CAP Aviation 9, rue de l'Aviation 21121 DAROIS - France Tel +33 380 35 65 10 Fax +33 380 35 65 15 www.capaviation.com	<b>S E R V I C E B U L L E T I N</b>	
<b>NUMBER</b>	<b>TITLE</b>	<b>ATA SYSTEM</b>
000705	Pulleys	27

This Service Bulletin corresponds to the MINOR change Nr 000705 which has been approved under the privileges of the Design Organisation Agreement DGAC Nr° F.JA.06.

Inform the users about the new references of the pulleys, supports and anti-derailing stops.

**Figure 1 :**  
Installation of the pulley

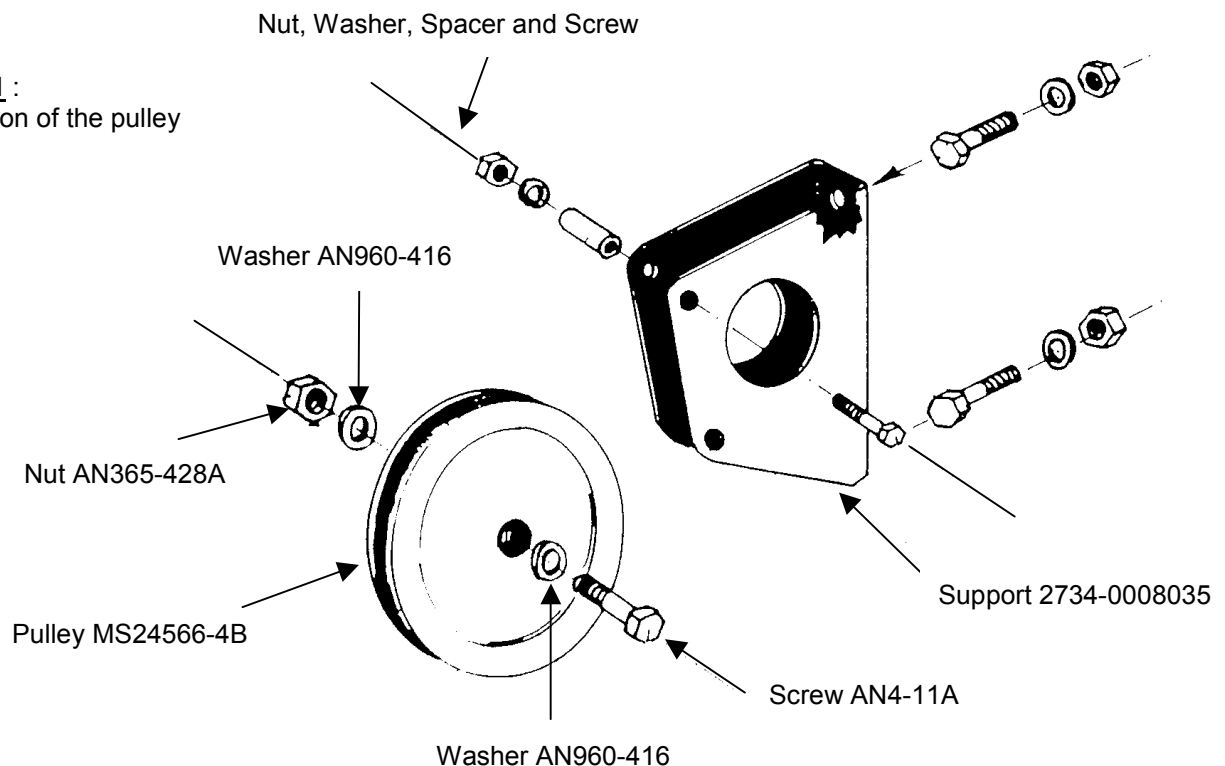
- A. Remove holding nut, washer, screw and spacer to free cable from support
- B. Remove support and pulley
- C. Remove pulley from support
- D. Attach new pulley (ref MS24566-4B) on new support (ref 2734-0008035) (figure 1)
  1. Install screw (ref AN4-11A) with a washer (ref AN960-416)
  2. Install nut (ref AN365-428A) with a washer (ref AN960-416)
- E. Install new support and pulley
- F. Install cable correctly in pulley
- G. Install spacer, screw, washer and nut on support to hold cable in position

**Figure 2 :**  
Installation of the pulley

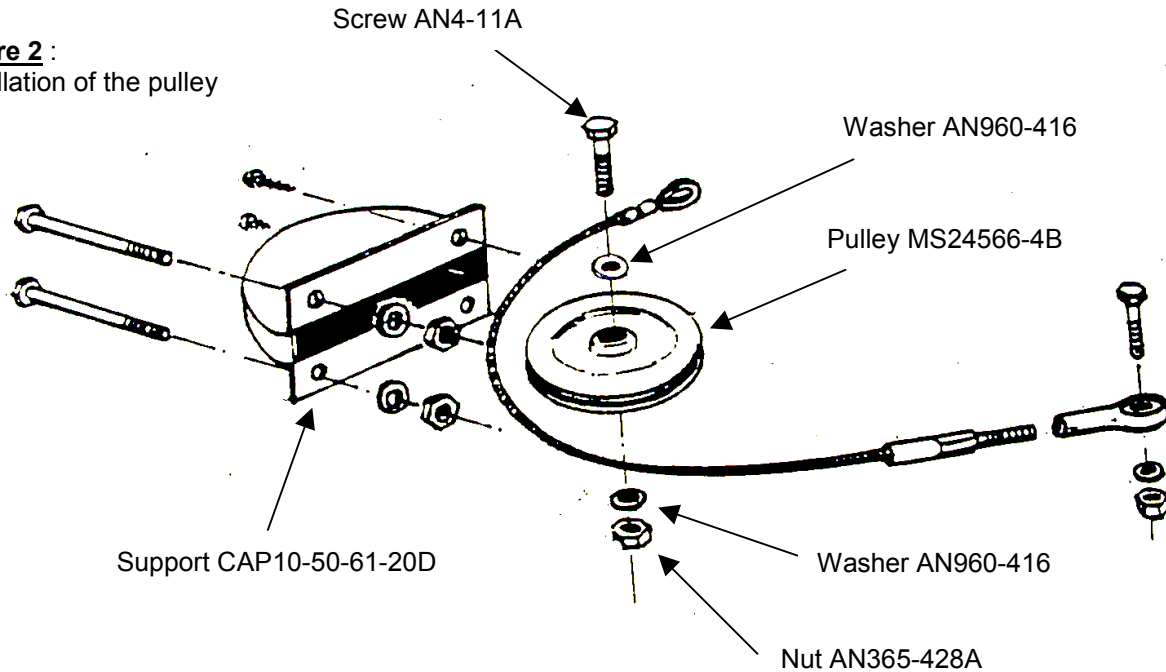
- A. Replacement of first pulley
  - 1. Remove support
  - 2. Remove pulley
  - 3. Install new pulley (ref MS24566-4B) and new support (ref CAP10-50-61-20D) (figure 2)
    - a) Set new pulley on new support making sure that cable is between pulley and support
    - b) Install new pulley on new support
      - i. Install screw (ref AN4-11A) with a washer (ref AN960-416)
      - ii. Install nut (ref AN365-428A) with a washer (ref AN960-416)
    - c) Install new support
- B. Repeat process for second pulley

**Figure 3 :**  
Installation of the aft pulley

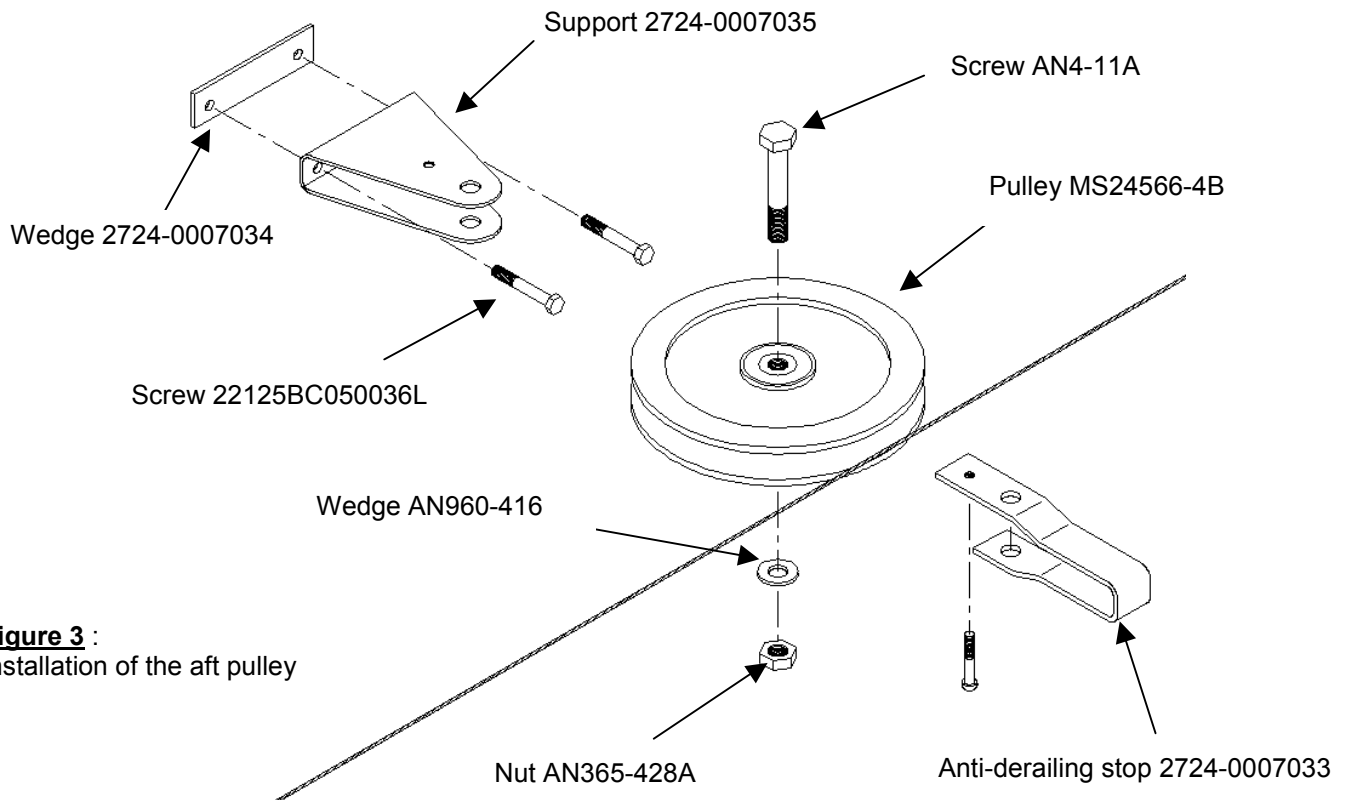
A. Installation of aft pulley (figure 3)

1. Remove pulley
2. Remove support and anti-derailing stop
3. Rivet new anti-derailing stop (ref 2724-0007033) on new support (ref 2724-0007035)
4. Put cable between support and anti-derailing stop
5. Install wedge (ref 2724-0007034) and new support (ref 2724-0007035) fitted with new anti-derailing stop (ref 2724-0007033) with the two screws (ref 22125BC050036L)
6. Install new pulley (ref MS24566-4B)
  - a) Install and align pulley axis and new support making sure that cable is correctly tight between pulley and anti-derailing stop
  - b) Install cable correctly in pulley gorge
  - c) Install screw (ref AN4-11A)
  - d) Install washer (ref AN960-416) and nut (ref AN365-428A)

**Figure 4 :**  
Installation of the forward pulley

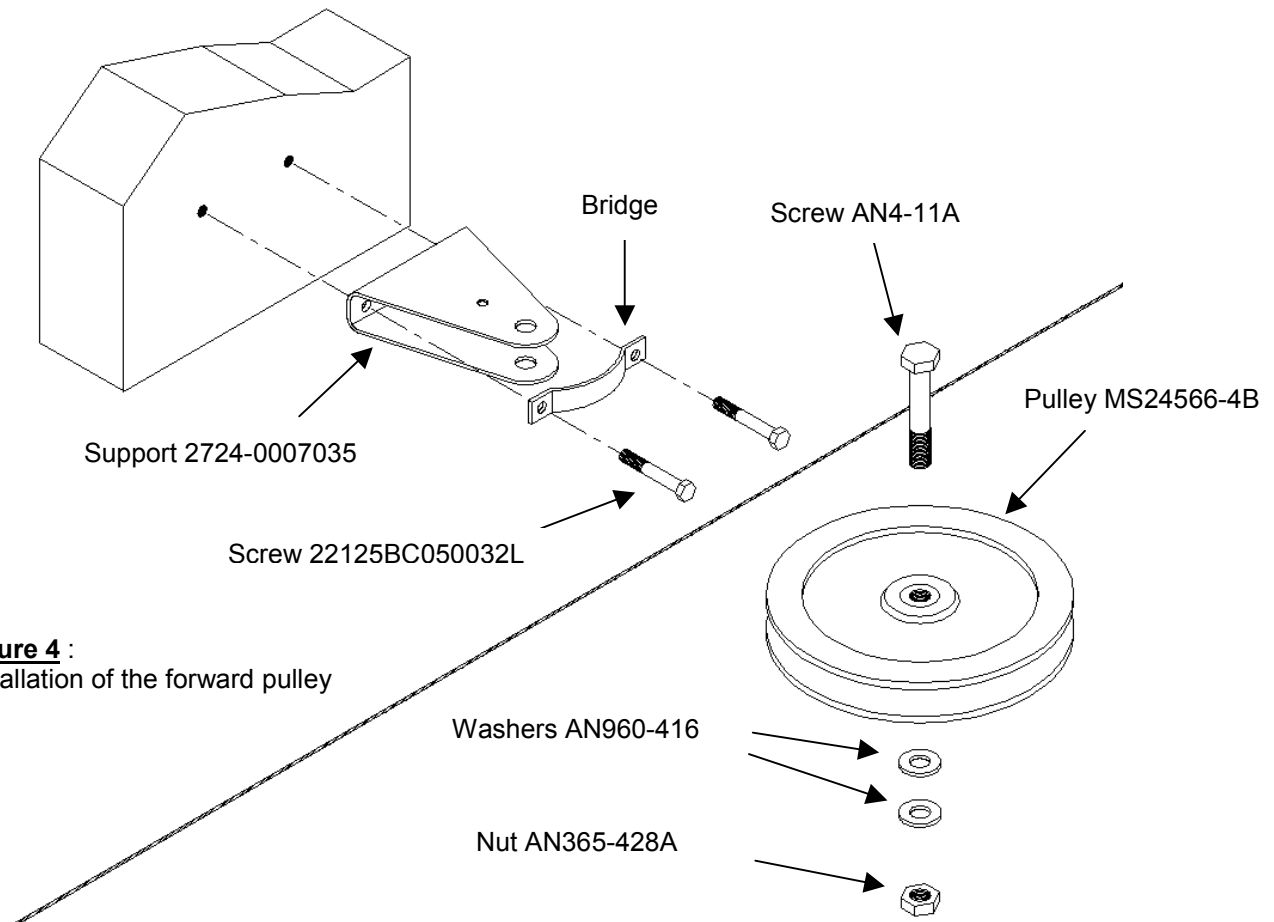
- B. Installation of forward pulley (figure 4)
1. Remove pulley
  2. Remove support and bridge
  3. Install new support and bridge
  4. Install new pulley making sure that cable is correctly put between bridge and pulley
    - a) Install screw (ref AN4-11A)
    - b) Install two washers (ref AN960-416) and nut (ref AN365-428A)
- C. Repeat process for aft and forward pulleys on other side
